Addendum 116 – UN Regulation No. 117

Revision 5 - Amendment 2

04 series of amendments – Date of entry into force: 24 September 2023.

Uniform provisions concerning the approval of tyres with regard to rolling sound emissions and/or to adhesion on wet surfaces and/or to rolling resistance

"Annex 2 - Appendix 1

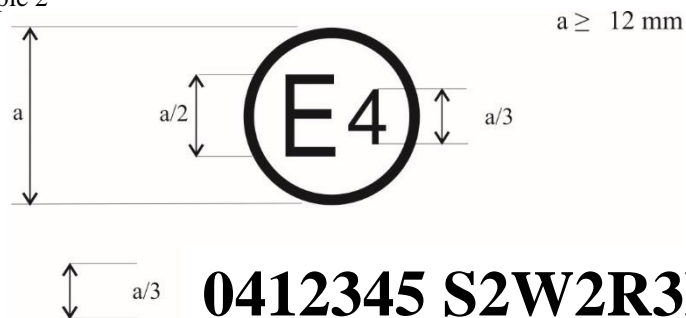
Appendix 1, amend to read:

The above approval mark, affixed to a pneumatic tyre shows that a tyre concerned has been approved in the Netherlands (E 4) pursuant to Regulation No. 117 (marked by S2 (rolling sound at stage 2) only), under approval number 0412345. The first two digits of the approval number (04) indicate that the approval was granted according to the requirements 04 series of amendments to this Regulation.

"Annex 2 - Appendix 2

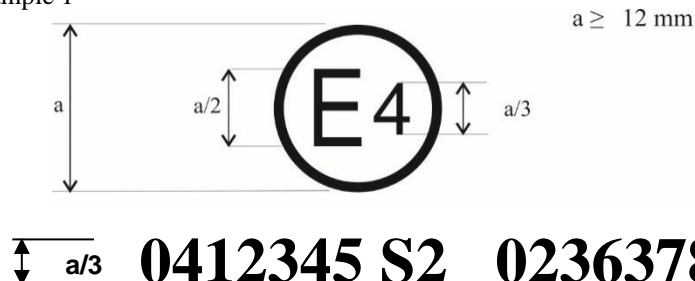
Appendix 2, amend to read:

The above approval mark shows that the tyre concerned has been approved in the Netherlands (E 4) pursuant to UN Regulation No. 117 (marked by "S2" (rolling sound at stage 2)), under approval number 0412345 and UN Regulation No. 30, under approval number 0236378. The first two digits of the approval number ("04" and "02") indicate that the approval was granted according to the 04 series of amendments and the approval pursuant to UN Regulation No. 30 according to the 02 series of amendments.

Example 2

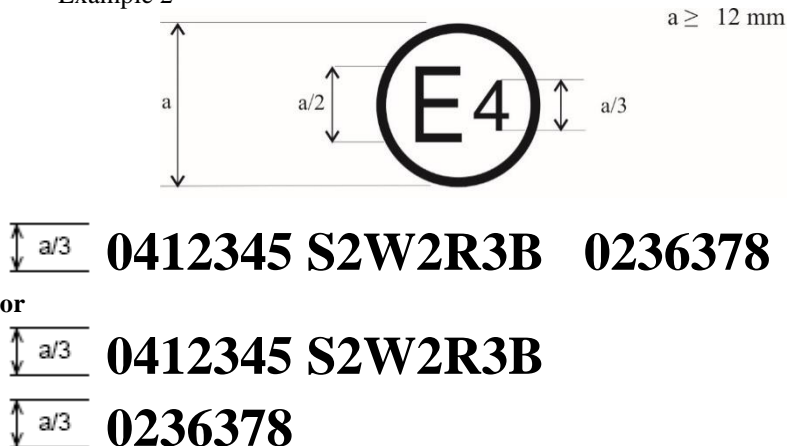
The above approval mark shows that the tyre concerned has been approved in the Netherlands (E 4) pursuant to Regulation No. 117 (marked by "S2W2R3B" (rolling sound emission at stage 2, wet adhesion of tyres in new state at stage 2, rolling resistance at stage 3 and wet adhesion of tyres in worn state)), under approval number 0312345 and UN Regulation No. 30 under approval number 0236378. The first two digits of the approval numbers ("04" and "02") indicate that the approval pursuant to UN Regulation No. 117 was granted according to the 04 series of amendments and the approval pursuant to UN Regulation No. 30 according to the 02 series of amendments."

Example 3

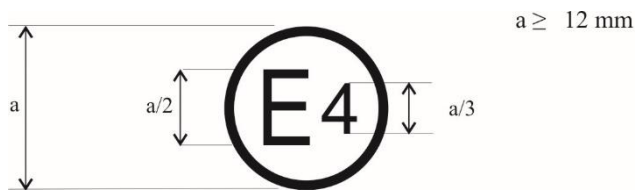
The above approval mark shows that the tyre concerned has been approved in the Netherlands (E4) pursuant to UN Regulation No. 117 (marked by "S2W2R3" (rolling sound emission at stage 2, wet adhesion of tyres in new state at stage 2 and rolling resistance at stage 3)), under approval number 0412345 and UN Regulation No. 54 under approval number 0065432. The first two digits of the approval numbers ("04" and "00") indicate that the approval pursuant to UN Regulation No. 117 was granted according to the 04 series of amendments and the approval pursuant to UN Regulation No. 54 according to its original form."

Example 1

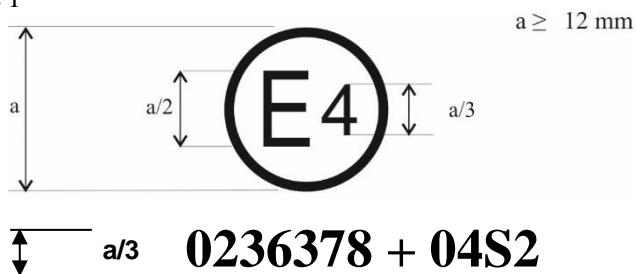
Appendix 3, amend to read:

The above approval mark shows that the tyre concerned has been approved in the Netherlands (E4) pursuant to UN Regulation No. 30 according to its 02 series of amendments (indicated by the first two digits of the approval number, "02") under approval number 0236378. It is also marked by "+ 04S2" which indicates that the tyre was also approved pursuant to UN Regulation No. 117 (04 series of amendments) for S (rolling sound emission at stage 2).

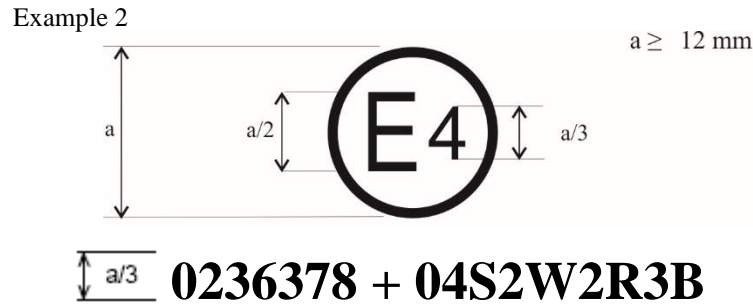
The above approval mark shows that the tyre concerned has been approved in the Netherlands (E4) pursuant to UN Regulation No. 30 according to its 02 series of amendments (indicated by the first two digits of the approval number, "02") under approval number 0236378. It is also marked by "+ 04S2W2R3B" which indicates that the tyre was also approved pursuant to UN Regulation No. 117 (04 series of amendments) for S (rolling sound emission at stage 2) W (wet adhesion of tyres in new state at stage 2), R (rolling resistance at stage 3) and B (wet adhesion of tyres in worn state)."

"Annex 2 - Appendix 4

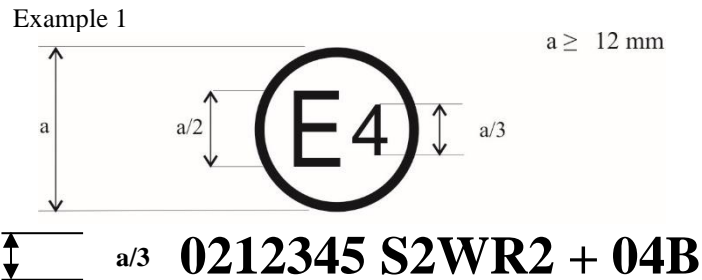
Appendix 4, amend to read:

The above approval mark shows that the tyre concerned has been initially approved in the Netherlands (E4) pursuant to UN Regulation No. 117 and the 02 series of amendments under approval number 0212345. The marking is complemented by S2WR2 (rolling sound emission at stage 2) W (wet adhesion of tyres in new state) and R (rolling resistance at stage 2). The "04B" preceded by "+" indicates that it has had its approval extended under UN Regulation No. 117 and 04 series of amendments to wet adhesion of tyres in worn state based on separate certificate."
